## **Reading Friends of the Earth: Objections to Reading Planning Application 200713**

Reading FoE object to this application - from Fairfax (Reading) Ltd & Reading Golf Club Ltd for construction of 260 houses - on grounds of Air Quality, Traffic and Transport, and Climate Change. Our failure to object on other grounds should not be taken to indicate approval.

Figure 3.7

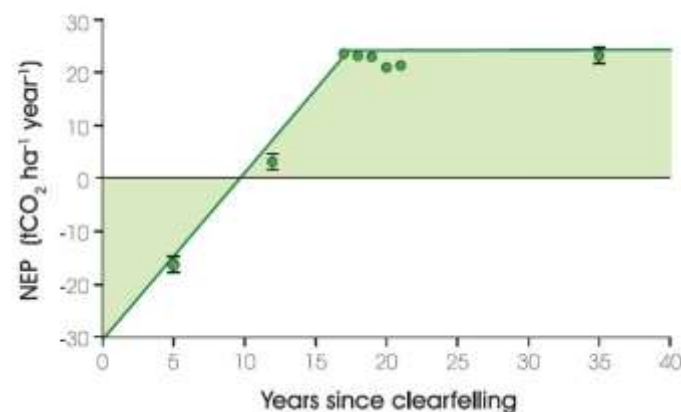
*Disagree with ‘marginally’ in context of urgency and RBC 2030 net zero target. Trees planted will typically be 5m high – some may die, all will take some time to get going, and some may well be pruned to keep in scale with development. Loss of soil carbon at establishment should be considered. At best canopies may have expanded by 2030 but sequestration in hardwood will scarcely have started by 2030. Need a credible short-term estimate of sequestration to 2030.*

Above diagram from the ‘Read Report’ - (Read, D.J., Freer-Smith, P.H., Morison, J.I.L., Hanley, N., West, C.C. and Snowdon, P. (eds). 2009. Combating climate change – a role for UK forests) – for Sitka Spruce plantation shows **there was initial large loss of carbon and it took about 17 years to reach maximum capture rate** and then capture rate stayed constant.
